**City of Phoenix
Office of the City Engineer
Design and Construction Procurement**

**WS90400085
LIFT STATION 40 REFURBISHMENT**

ADDENDUM NO. 4

ISSUE DATE: December 5, 2025

SITE PLAN LIGHTING AND GROUNDING

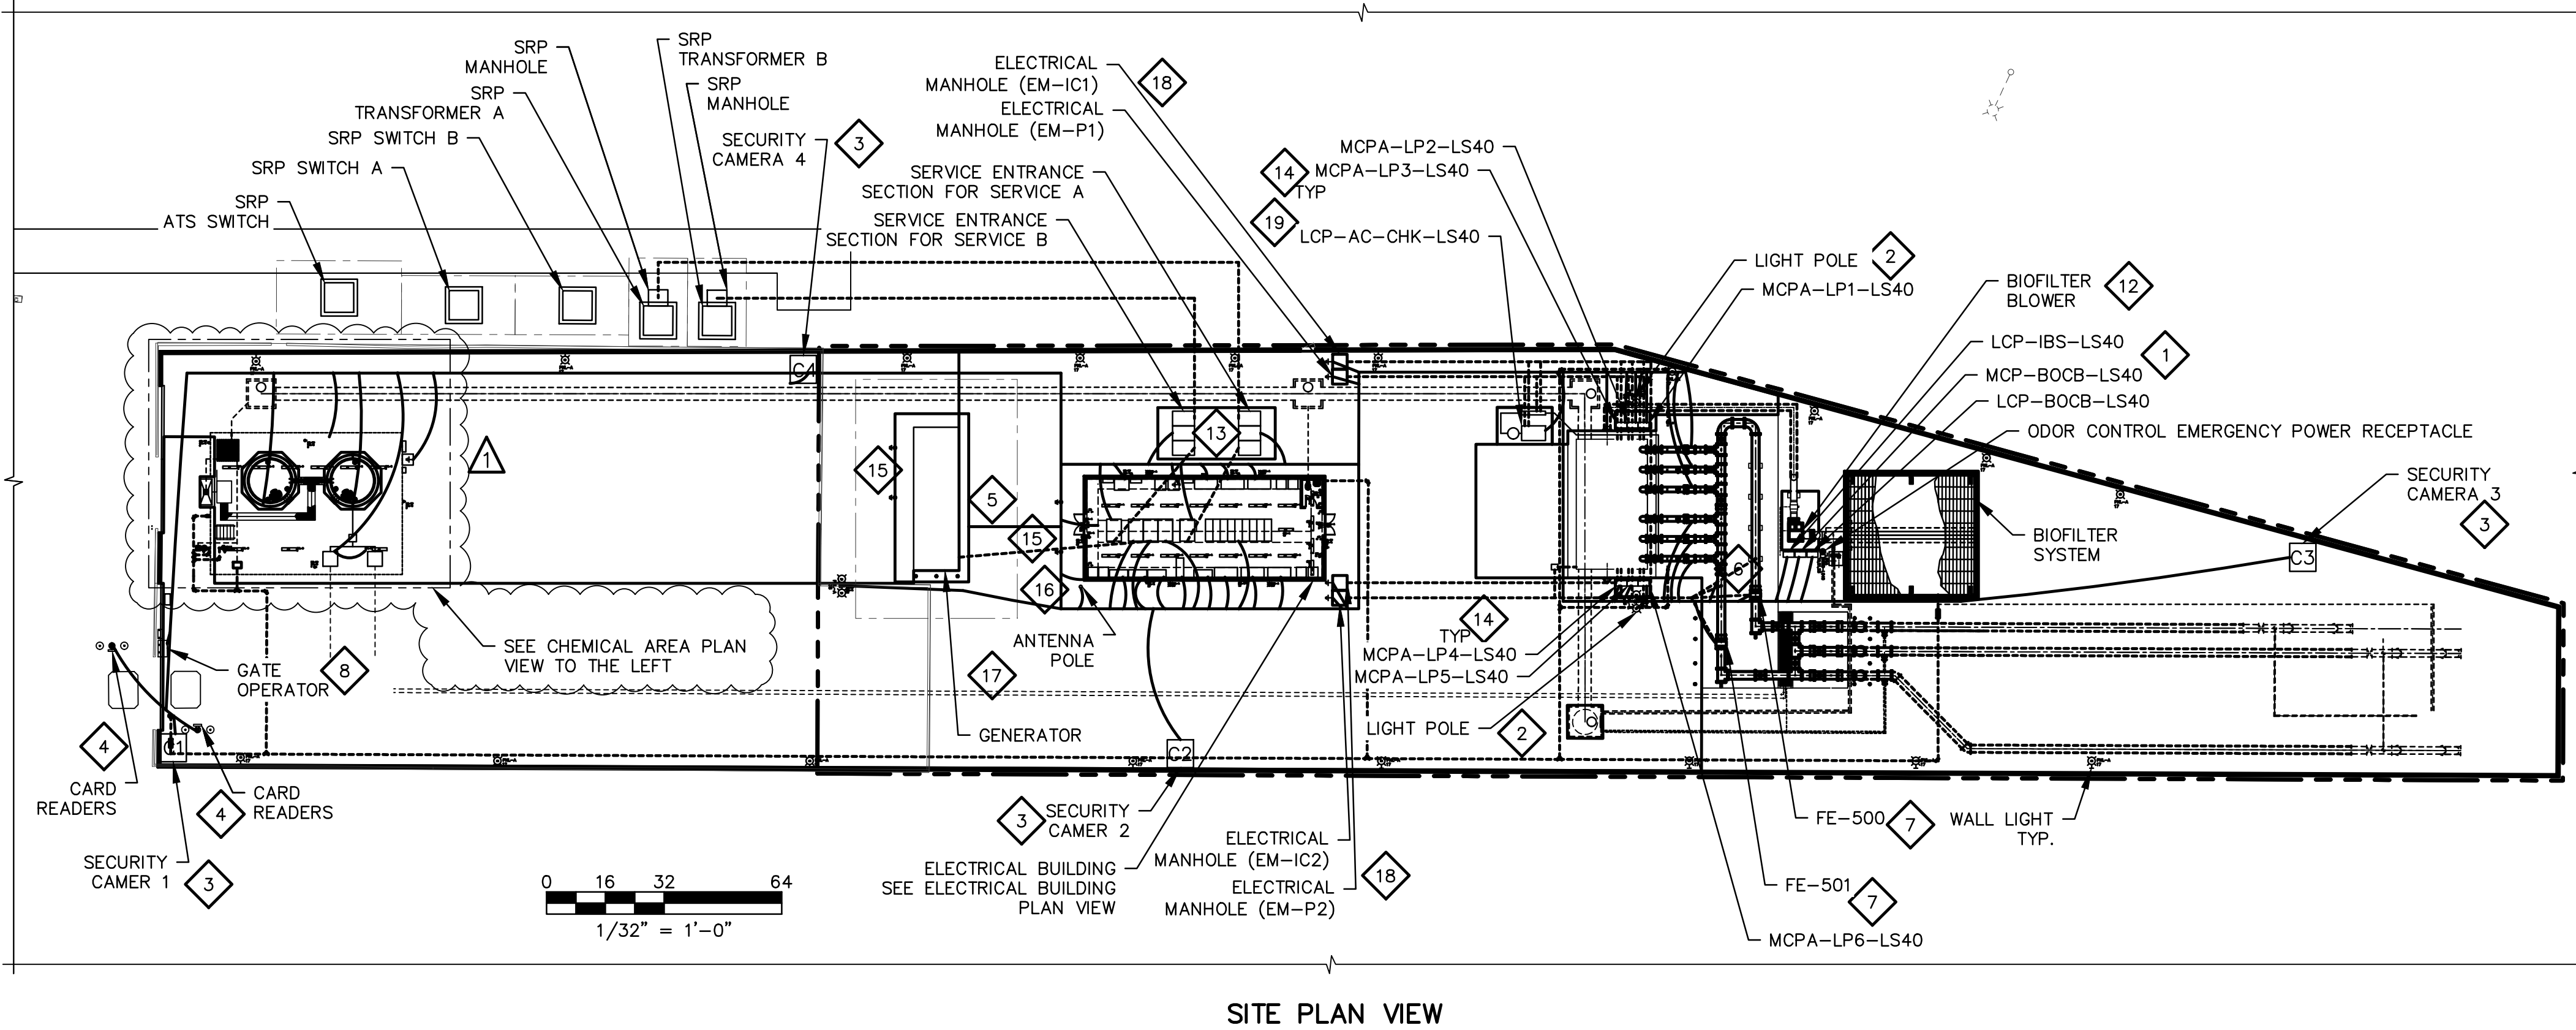
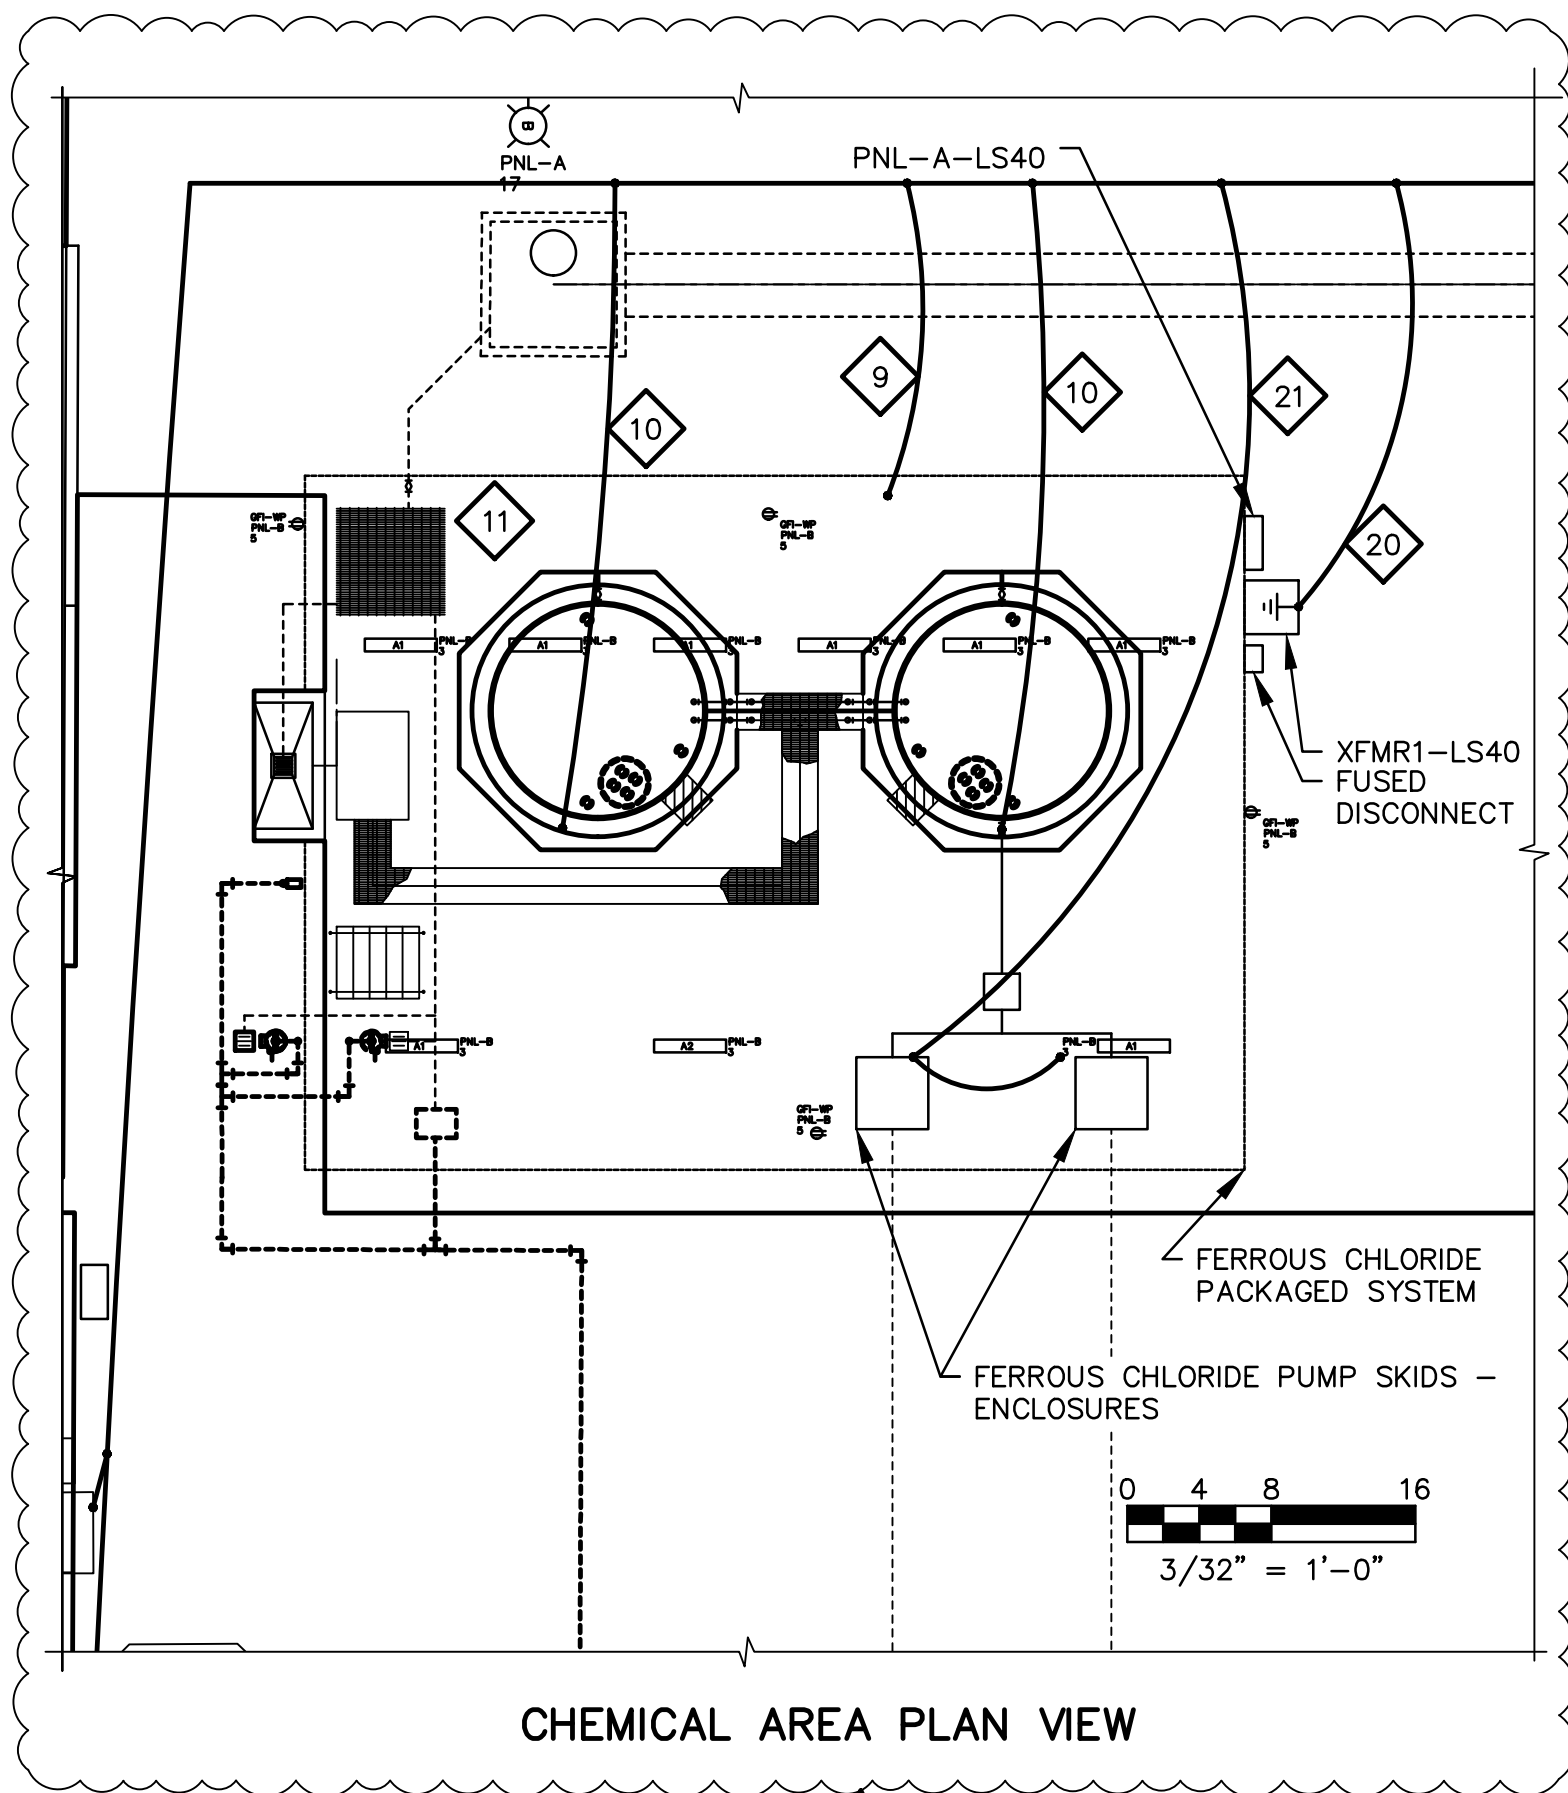
REPLACE: DRAWING E-12 – SITE PLAN LIGHTING AND GROUNDING
DRAWING E-14 – ELECTRICAL BUILDING LIGHTING AND GROUNDING
